Comment on Sheiling Track Retrospective Application

Image 4: Top half of the Sheiling Track averages a gradient of 12° exceeding that recommended as the limit in the SNH good practice guide “Constructed tracks in the Scottish Uplands” by 50%.

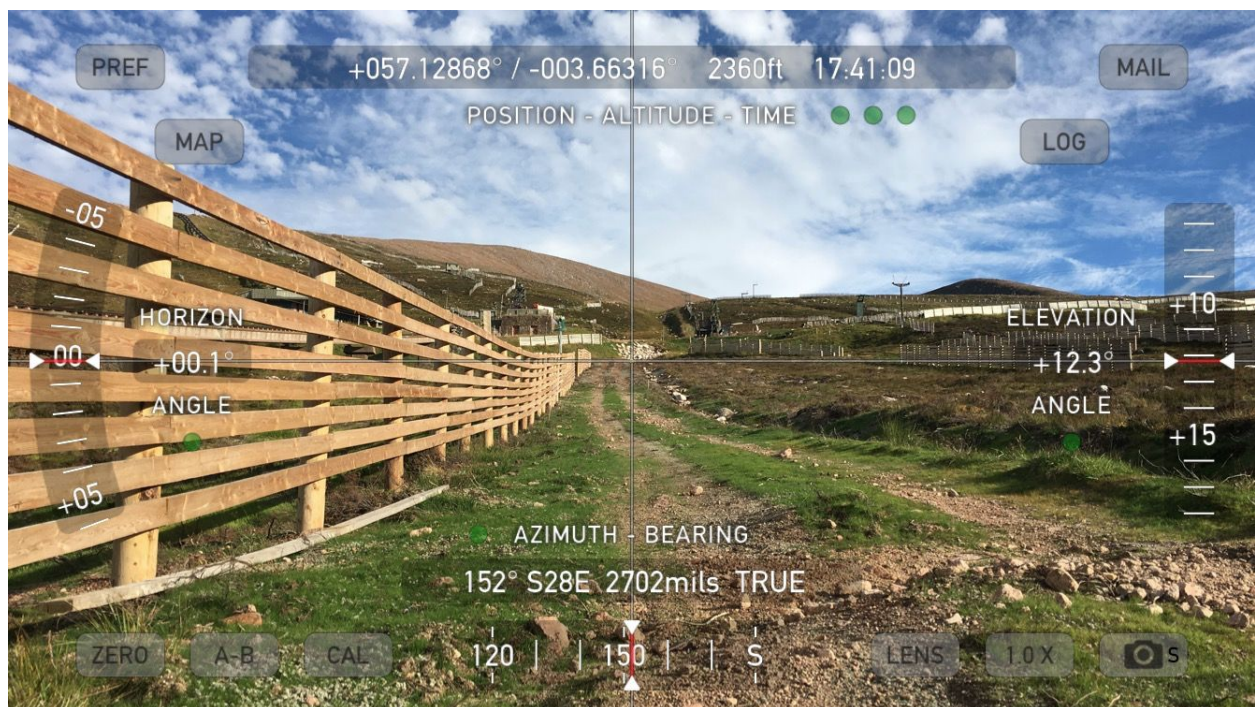
- The maximum recommended gradient in the SNH guide for light all terrain vehicle tracks is 8°:
 - The Sheiling Track exceeds this gradient, with the track averaging 12° on top half and reaching 15° (near top of rope tow and link onto pre-existing hill track).
 - Contrary to good practice the bulk of the track runs in a straight alignment at right angles to the contours of the land.
 - Lack of adequate drainage or camber to prevent water channeling and resulting erosion from track.
 - Central verge may help funnel run off down the exposed grit.
 - Steel box drains elsewhere on mountain quickly fill with washout and add to visual impact.

- The use of ground reinforcement grids (similar to those used at the funicular mid-station platform and winter entrance/exit from the Top Station), filled with suitable soil and seeded on top of the exposed grit would provide both a robust driving surface that would blend in almost entirely while stabilizing the ground thus preventing water run off erosion.
